DAWN MINING COMPANY
PO BOX 25
FORD WASHINGTON 99013

August 12, 1980

We have reviewed the D.S.H.S. Draft Environmental Impact Statement for The Proposed Dawn Mining Company Mill Tailings Expansion Project and offer the following general and specific comments on the various sections of that Document:

Figure 3.1 Dawn Mining Company
Flow Diagram for the Acid-Leach Process

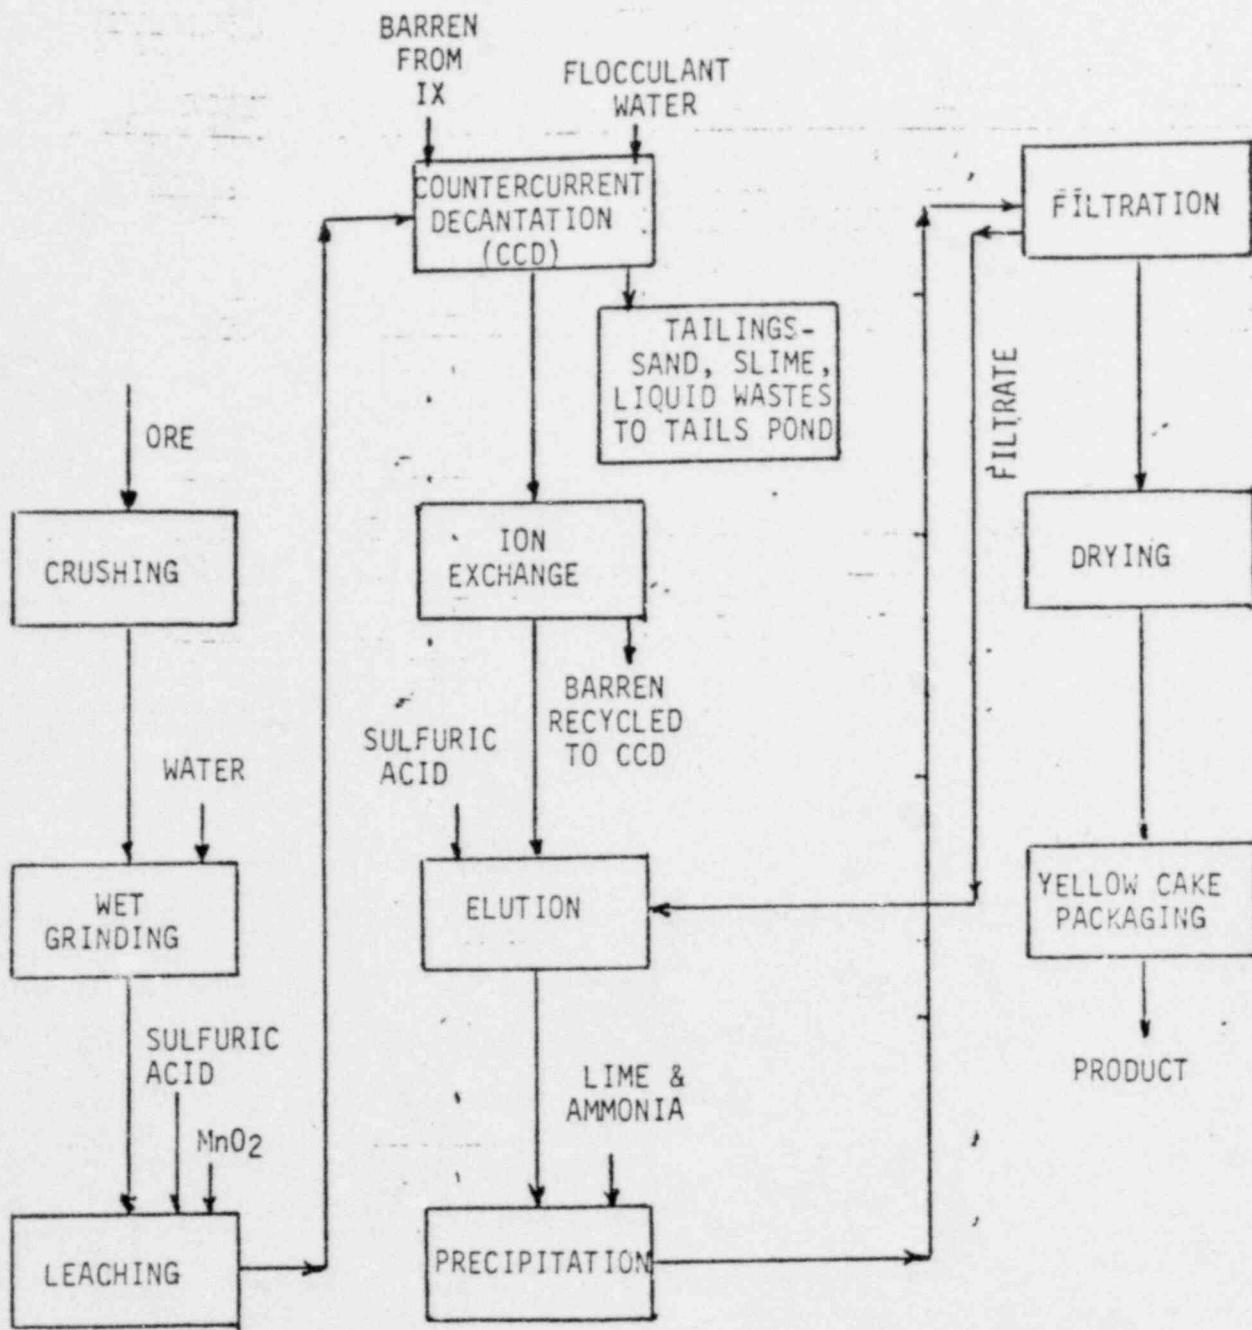
3.1.1 Mill Circuit

The flow diagram (Fig. 3.1) shown is for a mill using solvent extraction for solution treatment. Dawn's mill uses Ion Exchange (IX). A new Figure 3.1 is provided for your information.
